**Nebraska Public Power District**

NLS2016048  
August 26, 2016

**Subject:** Nebraska Public Power District's Final Six-Month Status Report in Response to March 12, 2012, Commission Order Modifying Licenses with Regard to Requirements for Mitigation Strategies for Beyond-Design-Basis External Events (Order Number EA-12-049)  
Cooper Nuclear Station, Docket No. 50-298, DPR-46

**Attachment 3**  
**Sketches (Confirmatory Item 3.2.4.8.C Response)**

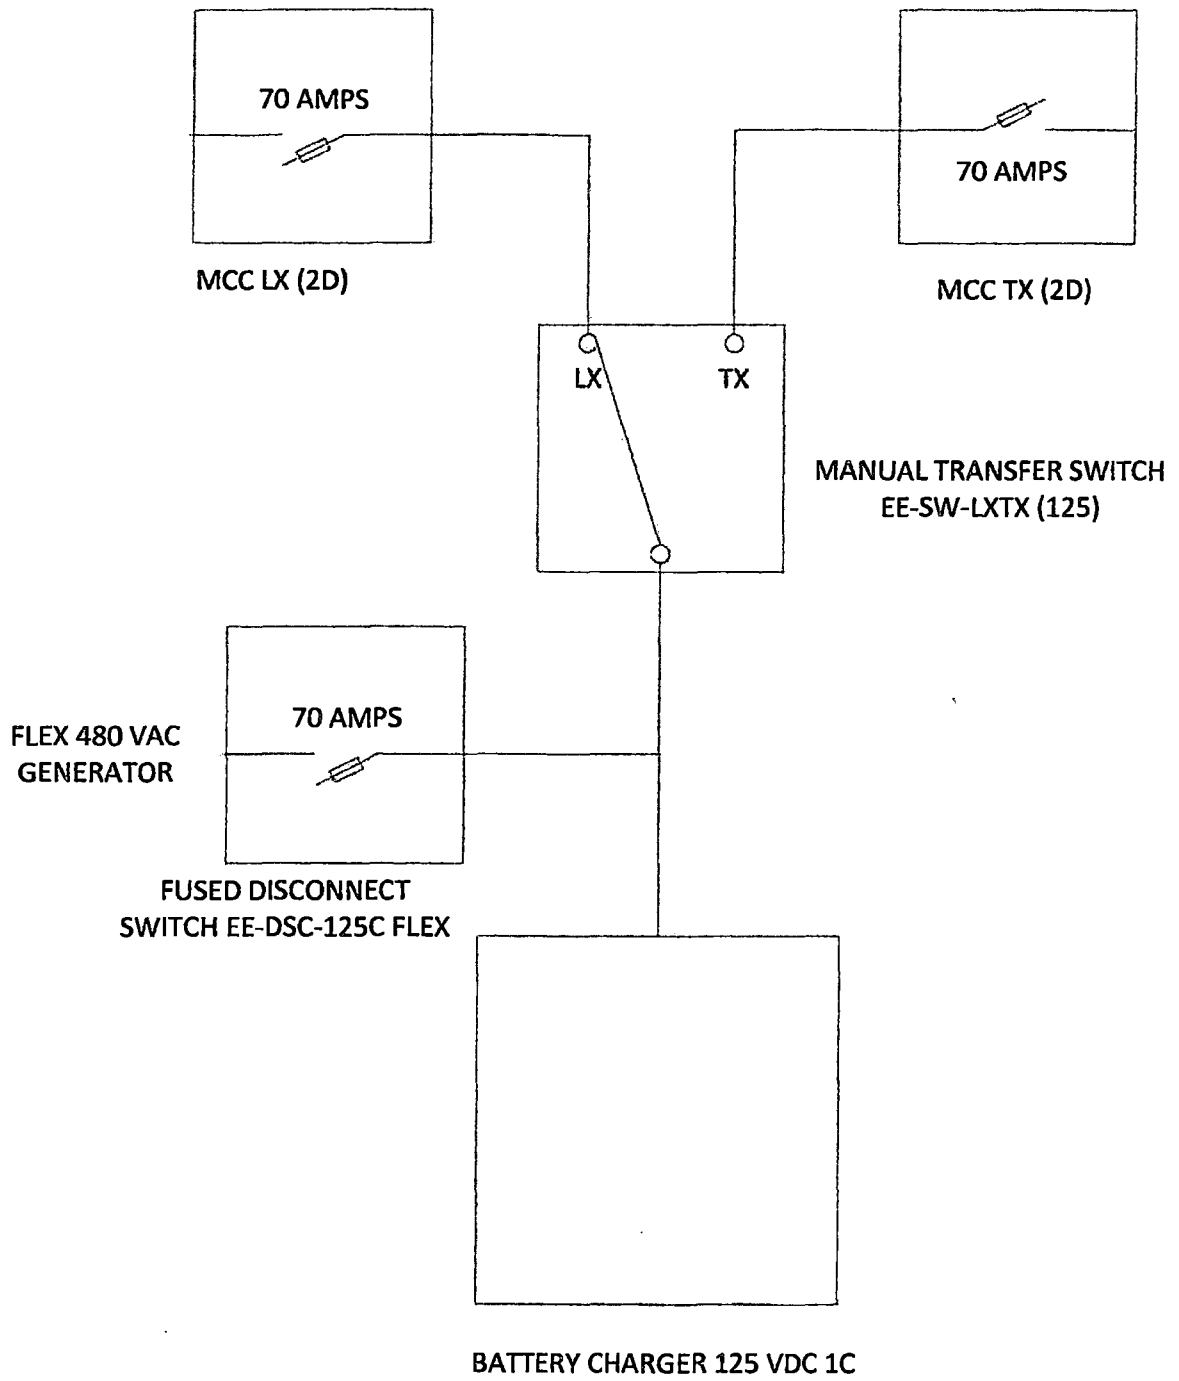
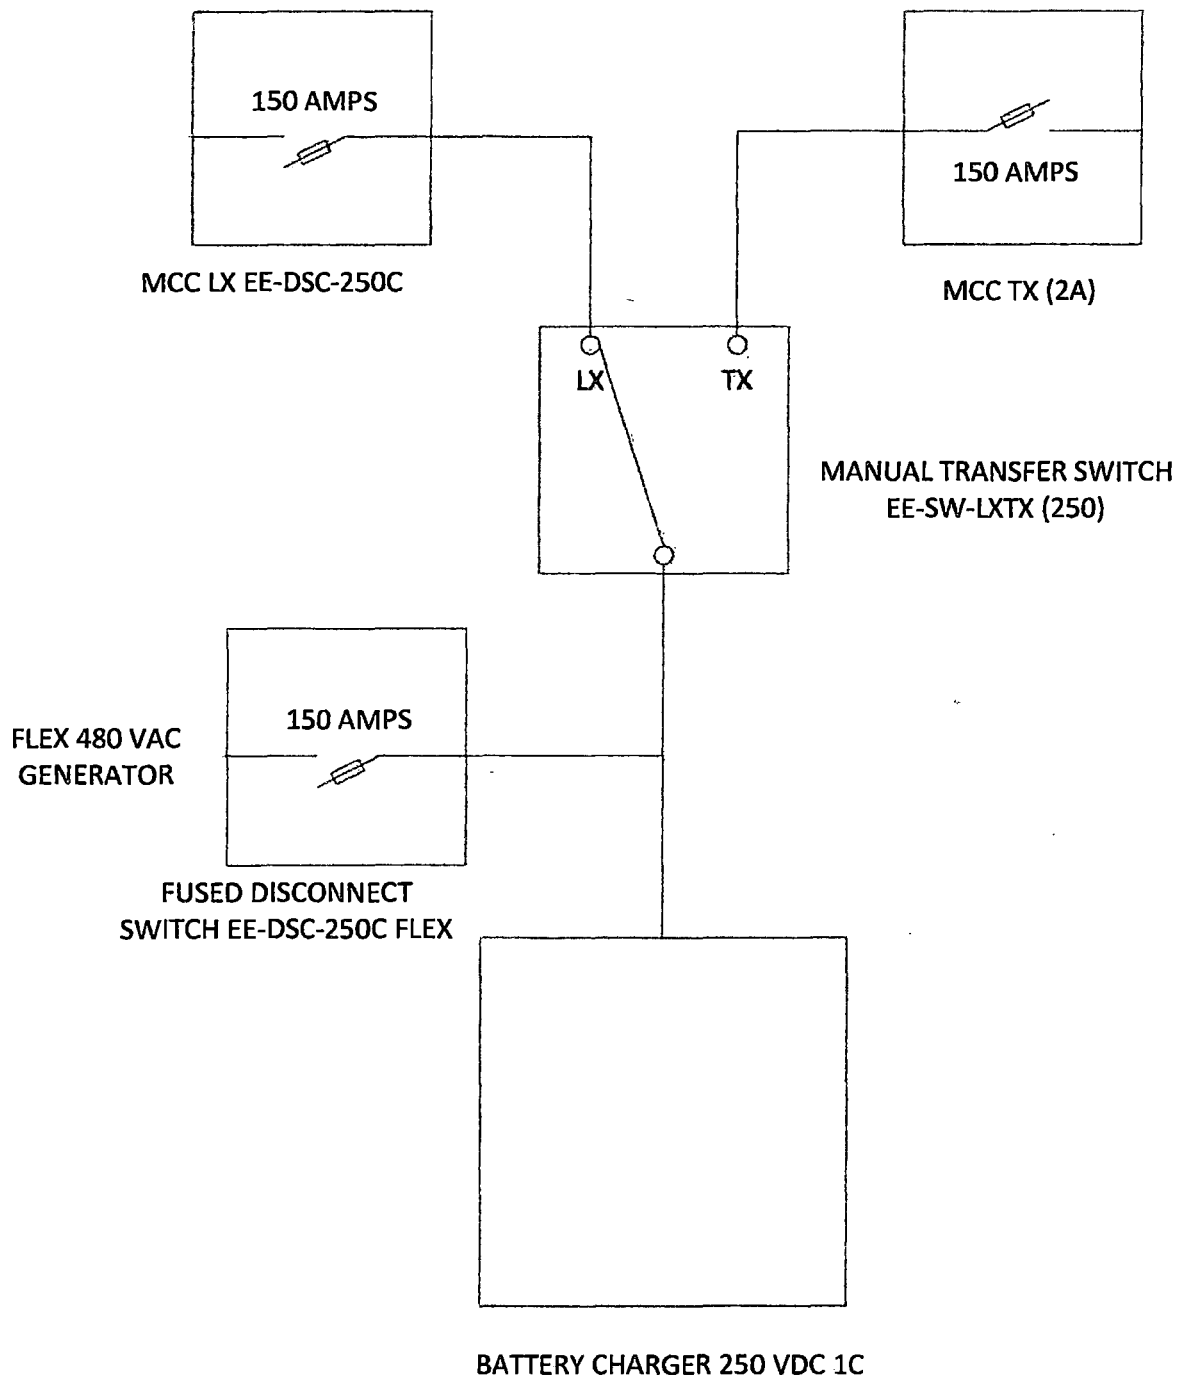
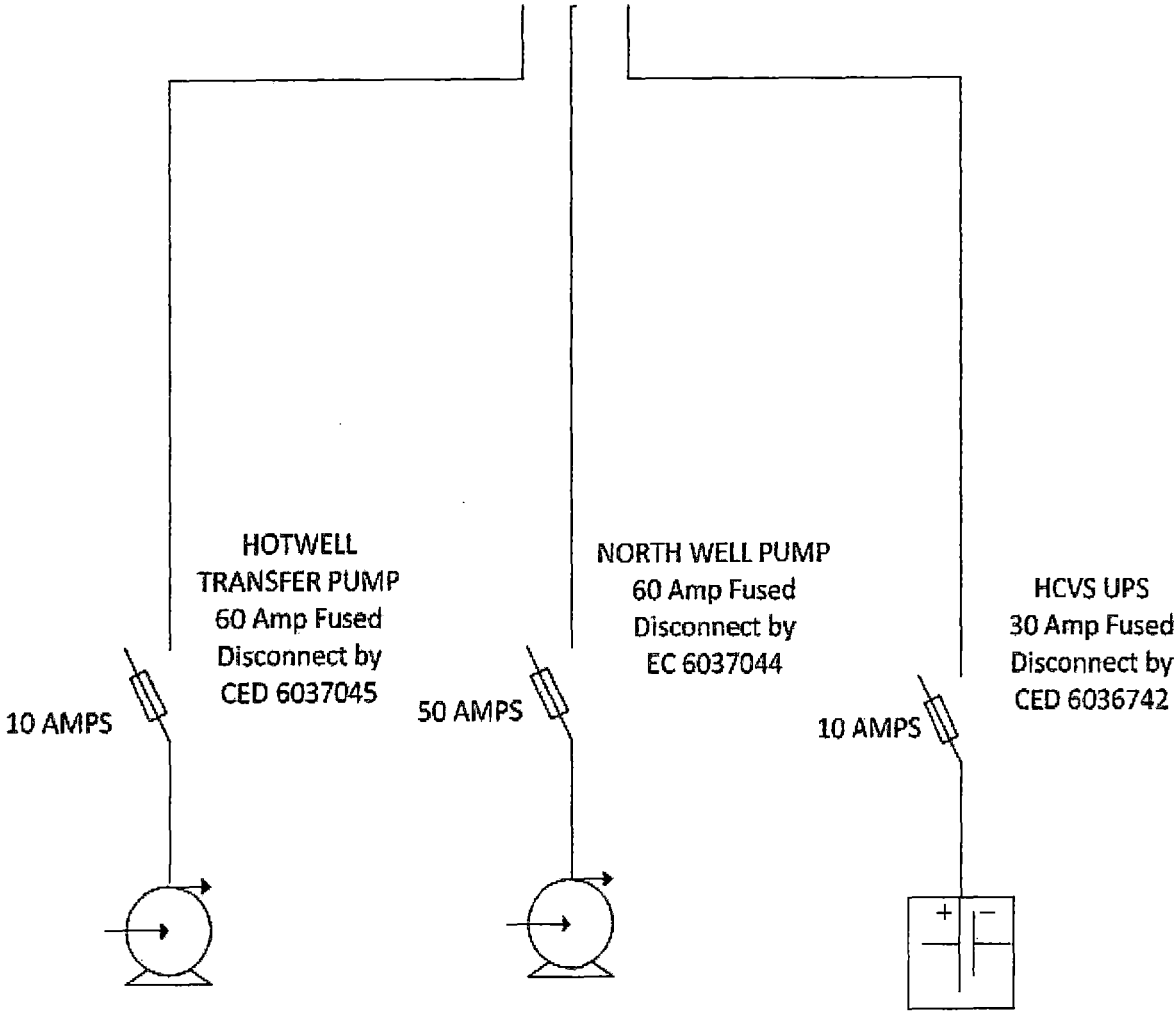
3.2.4.8.C	Provide single-line diagrams showing the proposed connections of Phase 2	<p>Sketches are provided in Attachment 3 to this submittal.</p>

ISE Confirmatory Items																								
Item Number	Description	NPPD Response																						
	and Phase 3 electrical equipment and showing protection information (e.g., breaker, relay, or fuse) and rating for the equipment used when available.																							
3.2.4.10.A	Confirm that the minimum dc voltage and dc load profile for the ELAP have been determined, the minimum dc bus voltage and the associated load profile supports CNS's proposed ELAP mitigation strategy.	<p>The ELAP load profiles are documented in:</p>

FLEX 480 VAC GENERATOR  
(55 KW)
